# UNITED STATES PATENT AND TRADEMARK OFFICE

APPLICATION NO.	FILING DATE	FIRST NAMED INVENTOR	ATTORNEY DOCKET NO.	CONFIRMATION NO.
10/501,612	07/14/2004	Eric Sitbon		2221

<b>Office Action Summary</b>	<b>Application No.</b>	<b>Applicant(s)</b>	
	10/501,612	SITBON ET AL.	
	<b>Examiner</b>	<b>Art Unit</b>	
	Marcus Menezes	3677

## **DETAILED ACTION**

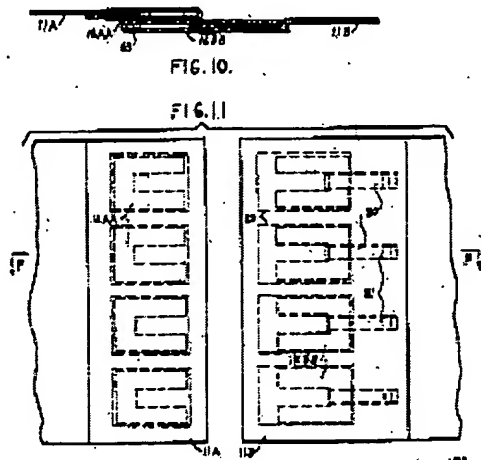
Regarding claims 1 and 3, Ellis discloses of an apparel fastener comprising of a first part equipped with at least one magnetic component (12BB) and a second part equipped with at least a second magnetic component (12AA). Ellis further discloses that this fastener is for securing clothing together. (See p. 1, col. 1, lines 1-5). Additionally, Ellis discloses that each magnetic component is composed of a magnet with positive and negative magnetic pieces, whereas the magnets of similar structure

are fixed directly or indirectly to the same support and are able to interact with magnetic pieces of opposite signs on a second magnetic component. (See Fig. 10 and 11).

Regarding claim 6, Ellis discloses of magnets (12AA) of the same component fixed rigidly among each other in an irremovable way. (See Fig. 11 above). Regarding claim 7, Ellis discloses of at least one component of magnets that are laid out in alternation between positive and negative magnets. (See Fig. 11 above). Regarding claim 8-9, Ellis discloses of magnets of the same component that are fixed side by side on the supports (11A, 11B) and of positive magnets on the opposite side of negative magnets, allowing for overlap of each magnetic component. (See Fig. 11 above). Regarding claim 14, Ellis discloses of a first sheath on support 11B where the first component is inserted and is mobile and within the sheath. (See Fig. 11 above). Regarding claims 16 and 17, Ellis discloses of a second magnetic component (12AA) that is fixed and of first and second components comprising of two sheaths. (See Fig. 11 above). Regarding claim 20, Ellis discloses that one of the first or second parts (11A, 11B) are formed by a strap. (See p. 1, col. 1, lines 1-5). Regarding claim 21, Ellis discloses that of a magnetic field is formed by the magnetic component on the apparel
